August 22, 2022

RE: Submission of 2022 Geotechnical Inspection Report No. 1 (June 2022)

The first geotechnical inspection for 2022 was conducted by Laszlo Bodi, M.Sc., P.Eng., Principal Civil/Geotechnical Engineer with Wood Environment and Infrastructure Solutions. The focus of the inspection was on the Water Licence related infrastructure located at the Mary River Mine Site and Milne Port. The first geotechnical inspection for 2022 was conducted between June 21 and 24, 2022.

Figure 13: View of stable berms around HWB-2. The wooden pallets should be removed.

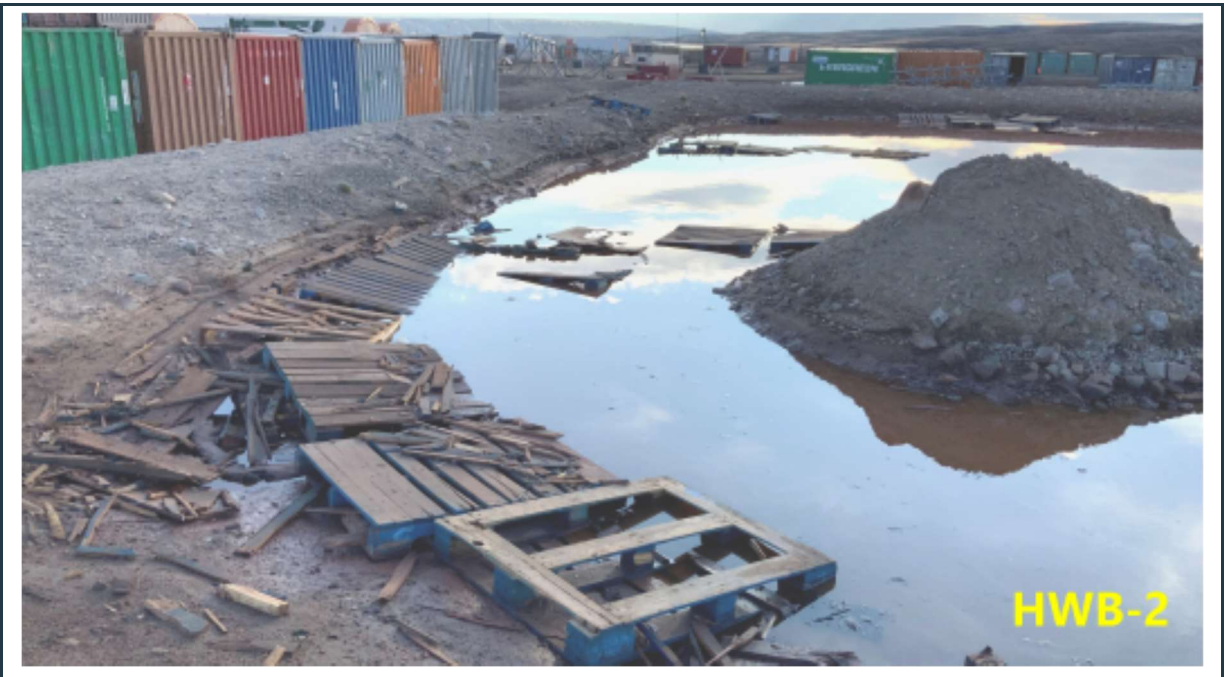
Wooden pallets observed in the cell should be removed to prevent potential damage to the liner.

As shown in Figure 13, some heterogeneous soil is currently stored in this cell. Materials stored previously on wooden pallets have been recently removed. The perimeter berms around the cell appear to be stable and no visible seepage from the cell was noted around the berm. Ponding water in the cell indicates that the HDPE liner is intact, and that the cell is operating as intended. It is recommended that the wooden pallets be removed from the cell to prevent potential damage to the liner.

Baffinland Action: Baffinland will remove the wooden pallets and wooden pallet debris from HWB-2, to prevent potential damage to the liner, during routine maintenance activities.

Figure 16: View of the berms around the currently empty HWB-5 cell. The cell is not in use for years.

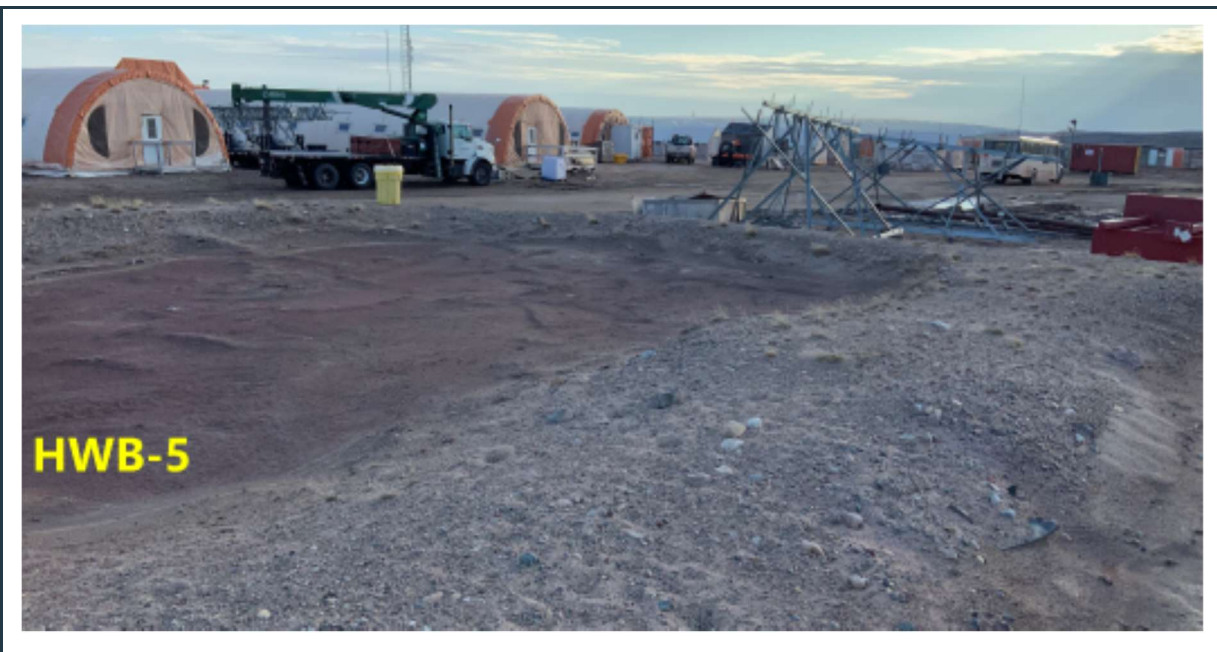
As shown in Figure 16, the cell is currently empty. The shallow berms around this cell appear to be stable and there is no visible liner damage in the cell. Should material be stored in this cell again it may become necessary to regrade the granular fill within the cell to prevent potential liner damage in the future. Baffinland has previously committed to removing the old liner from this cell and replacing it with a new one should use of this HWB be required in the future, prior to storing material in the cell.

Figure 34: Solid waste landfill facility with ponding water along a section of the perimeter fence.

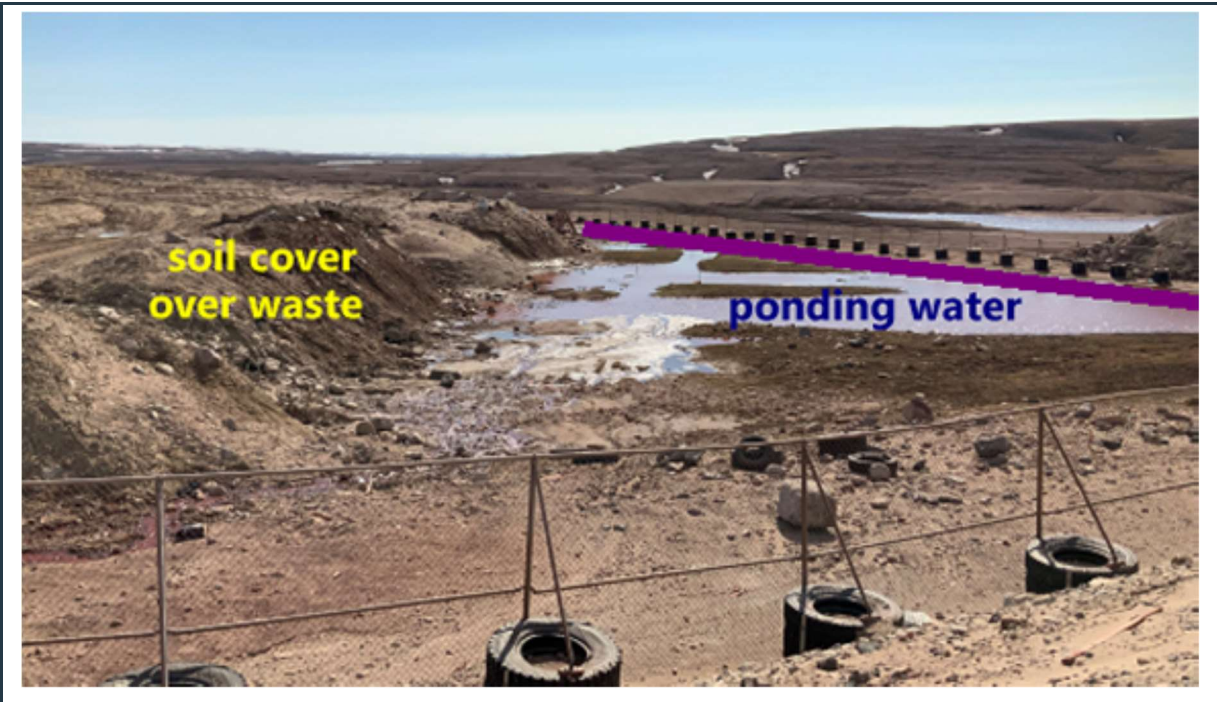
Surface water was ponding along a section of fence during the June inspection, and some of that water may flow out of the facility uninterrupted. To prevent the migration of suspended solids into the surrounding environment, it is recommended that an erosion and sediment control berm be constructed inside the fence. Similar observations were made during the first geotechnical inspection in 2021.

The solid waste disposal area is located in the southern zone of the Mary River Mine Site, as shown in Figure 4. Only non-hazardous solid waste is placed into this unlined facility and the site is surrounded by a chain-link fence and a lockable gate. As shown in Figure 34, the disposed waste is covered with soil, as per standard procedure at such a facility. The figure also shows surface water ponding along a section of fence that was observed during the June inspection. Some of that water may flow out of the facility uninterrupted. To prevent the migration of suspended solids into the surrounding environment, it is recommended that an erosion and sediment control berm be constructed inside the fence along the purple line shown in Figure 34.

Baffinland Action: Water quality results at surface water drainage monitoring stations located down-gradient of the non-hazardous waste landfill do not indicate any impact to the downstream receiving environment from surface water runoff at the solid waste facility. Baffinland will continue to monitor the ponding water and receiving environment water quality and will implement mitigation measures if monitoring indicates a potential water quality issue.

Figure 36: Camp Lake check dams, berms, and sedimentation cells. Note the recently completed riprap slope protection and new check dam at the adjacent side-slope (yellow ellipse).

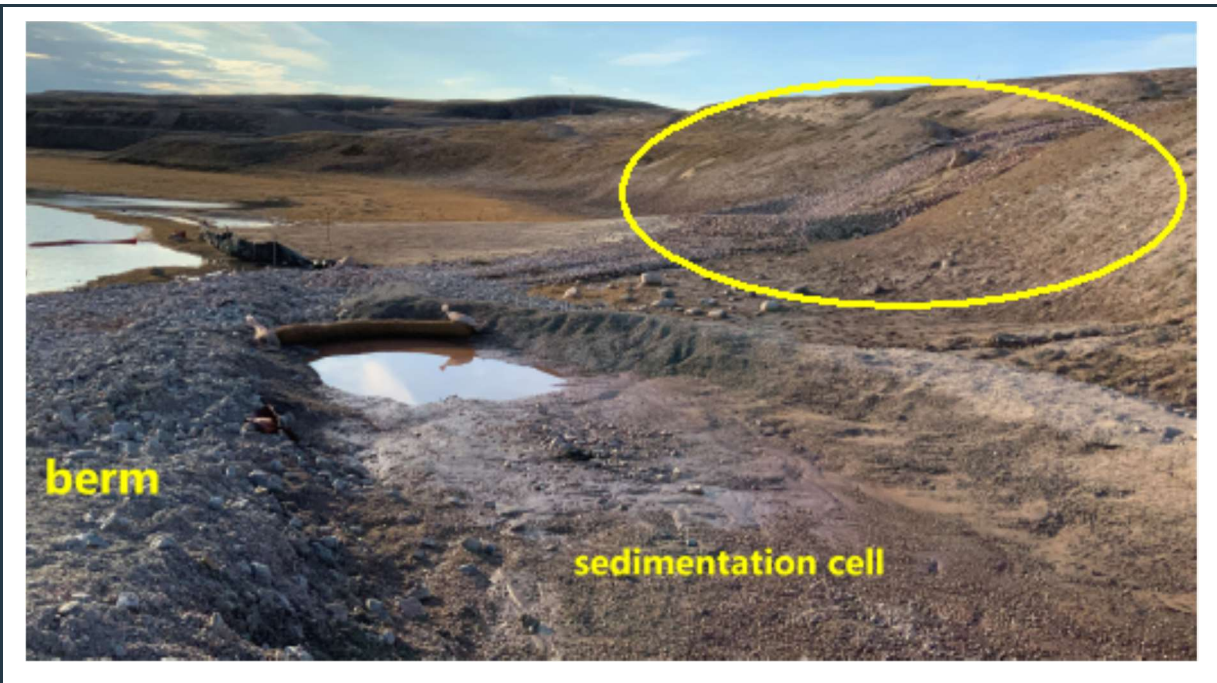
The Camp Lake silt sedimentation control berms and check dams, which were observed to be stable and well-maintained, are located along the access road to the mine's water intake jetty. The primary purpose of these structures is to collect fine soil particles (silts and clays) that are eroded down from the adjacent slopes, and to prevent the siltation of the lake around the water intake structure, as shown in Figure 36. The image shows that the cells are working well and as intended for their purpose. The image also shows the recently completed riprap slope protection and new check dam at the adjacent side-slope (yellow ellipse).

Figure 51: View of the lined, stable berm along the south and west sides of settling pond #3.

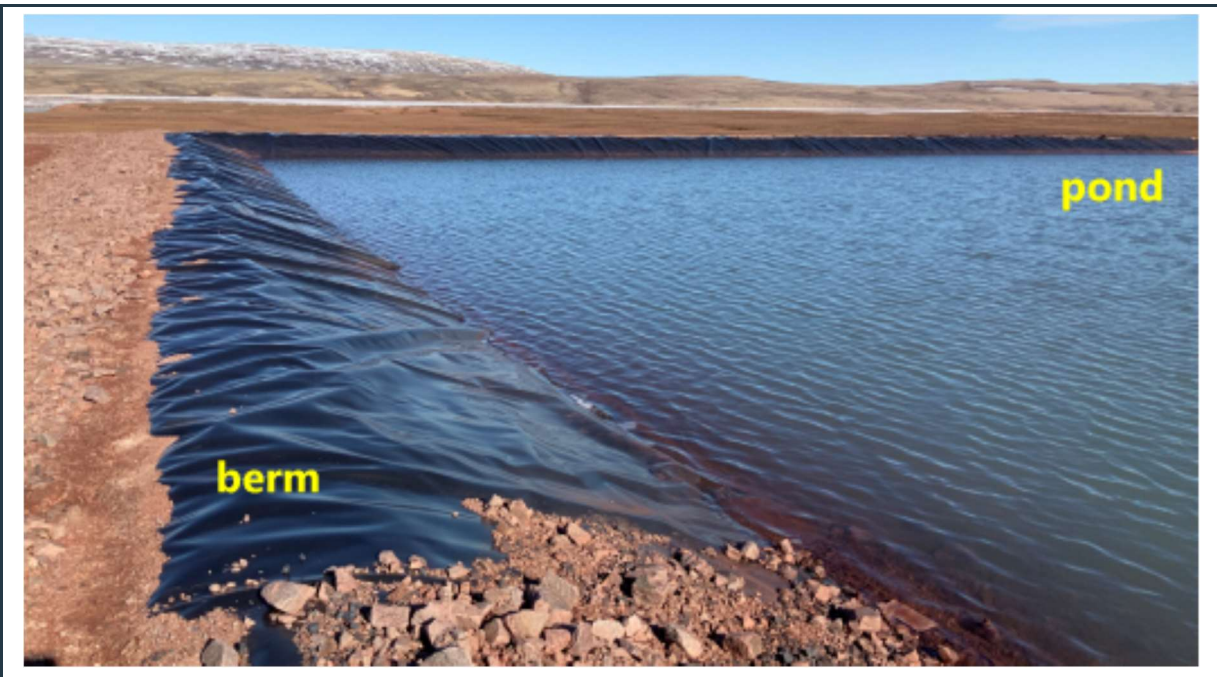
Settling Pond #3 was constructed west of the ore storage area, as shown in Figure 6. There are robust, stable, lined berms along three (3) sides of the pond (Figure 51) that contains two (2) sumps. The geomembrane liner and protective geotextile on the internal slope of the berms were designed to extend 2.5 m below the surface and are anchored into the permafrost zone to prevent any seepage from the pond into the ground below and around the pond. Excess water from the pond is pumped into the nearby, large capacity MP-06 settling pond, whenever necessary.

Figure 61: Clogged culvert at the entrance to the quarry in P-SWD-5 – “Q01-North” surface water collection ditch. The south section of the ditch is flooded and the collected water flows onto the road to the quarry.

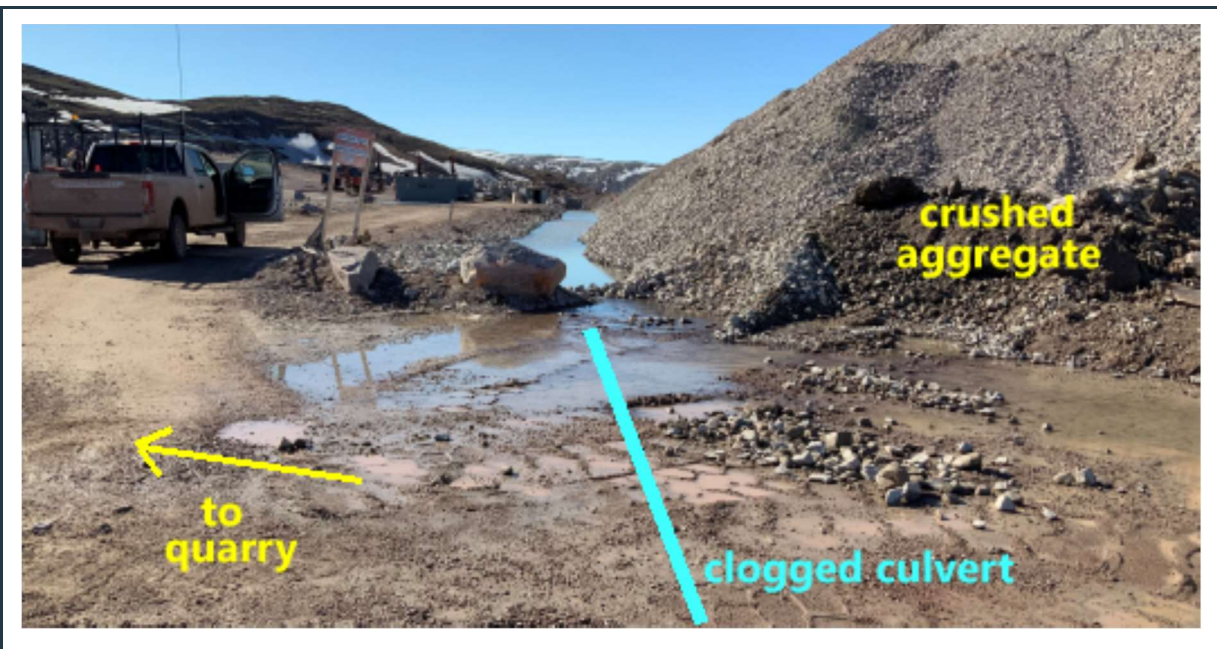
A short section of the P-SWD-5 ditch was noted with missing riprap and continuous water seepage from the side-slope, as shown in Figure 60. This section of the ditch should be repaired, and the side-slope covered with geotextile and riprap. Due to the increased localized seepage from the quarry at that location, placement of a more robust riprap slope protection is recommended. Figure 61 also shows that there is a clogged culvert along this ditch, located beneath the road at the entrance to the quarry. As a result, the south section of the ditch is flooded and the water from the ditch flows onto the road's surface around the entrance to the quarry. The clogged culvert should be cleaned, or if damaged, should be replaced, preferably with a larger diameter culvert.
